RICHWOOD BANK - DELAWARE/VALLEY RUN DRIVE

**Re: Construction Storm Water Inspection at Richwood Bank-Delaware/ Valley Run Drive /
Delaware County
Permit Number: 4GCO00045*AG**

Figure 1

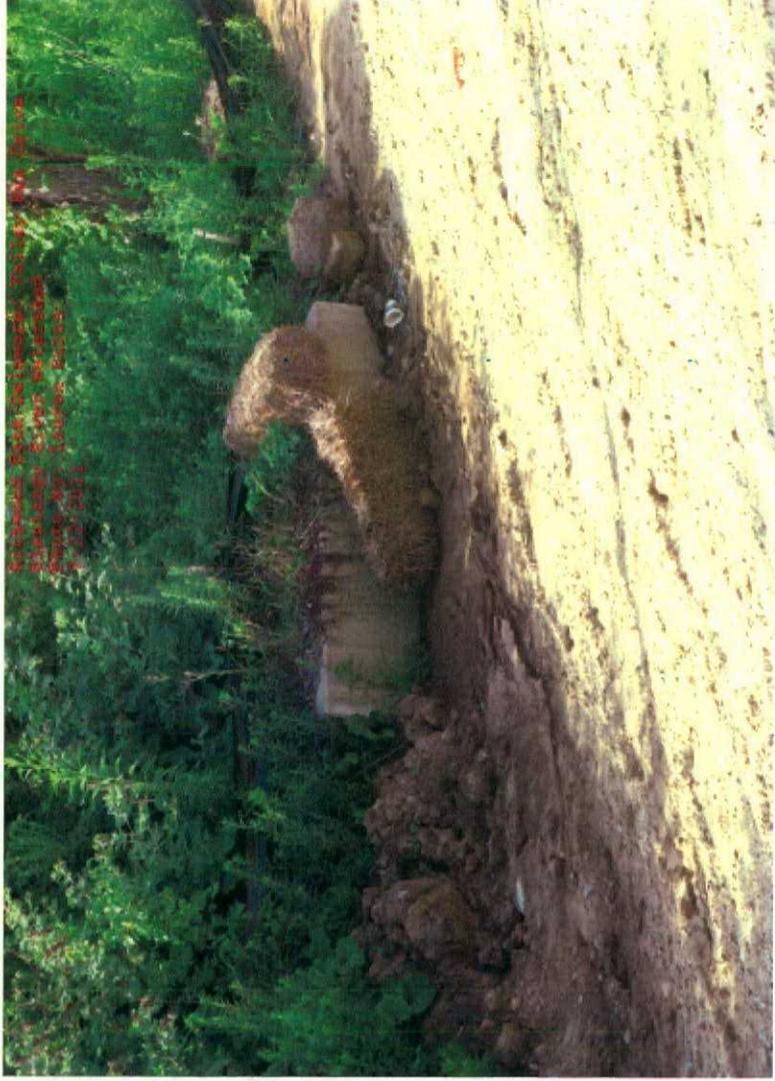
- During the inspection our staff, was informed by the contractor of the installation of a sediment pond. Please be advised that the sediment pond must comply with all regulations and guidelines listed in the General Permit.
- Installation of silt fence is required around the storm drain located on the south end of the site. Please ensure that the installation and maintenance of the silt fence complies with General Permit (see Figure 1).
